# UNITED STATES PATENT AND TRADEMARK OFFICE

APPLICATION NO.	FILING DATE	FIRST NAMED INVENTOR	ATTORNEY DOCKET NO.	CONFIRMATION NO.
09/273,448	03/22/1999	SHINGO OHKAWA	1185.1044/JD	7146
21171	7590	09/20/2005	EXAMINER	
STAAS & HALSEY LLP SUITE 700 1201 NEW YORK AVENUE, N.W. WASHINGTON, DC 20005			NGO, HUYEN LE	
			ART UNIT	PAPER NUMBER
			2871

**Office Action Summary**

## **DETAILED ACTION**

Fig. 2

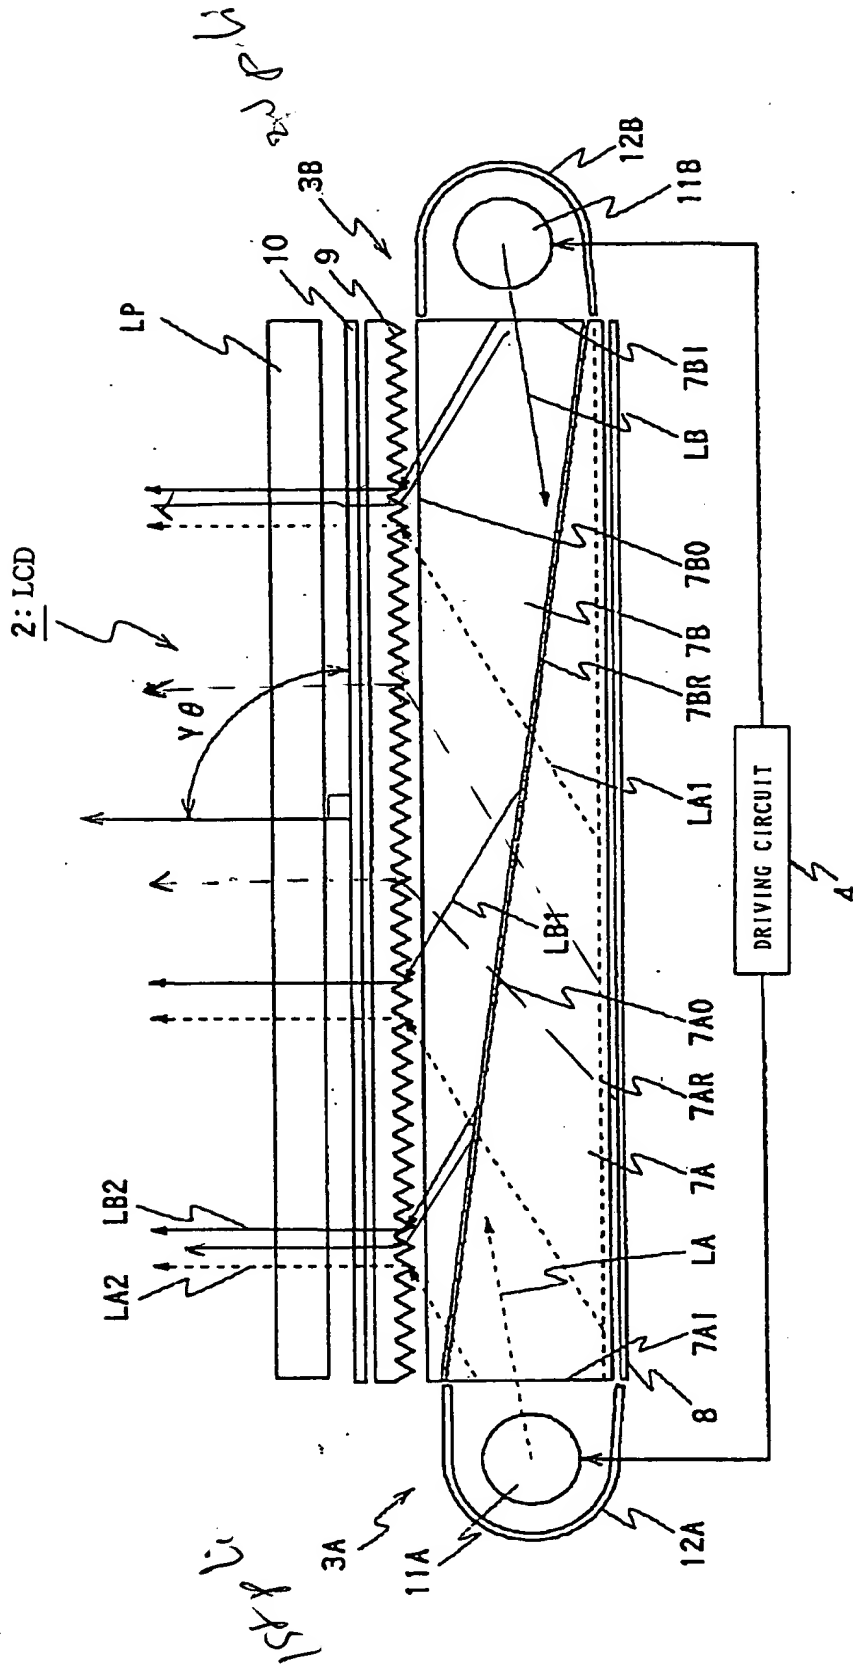
However, in Figure 2 of instant application, The light rays are receivable in all directions; therefore, **there is nothing to avoid** that the first and second slopes BOTH receive light from first primary light source or second primary light source (See attachment for other possible light rays).
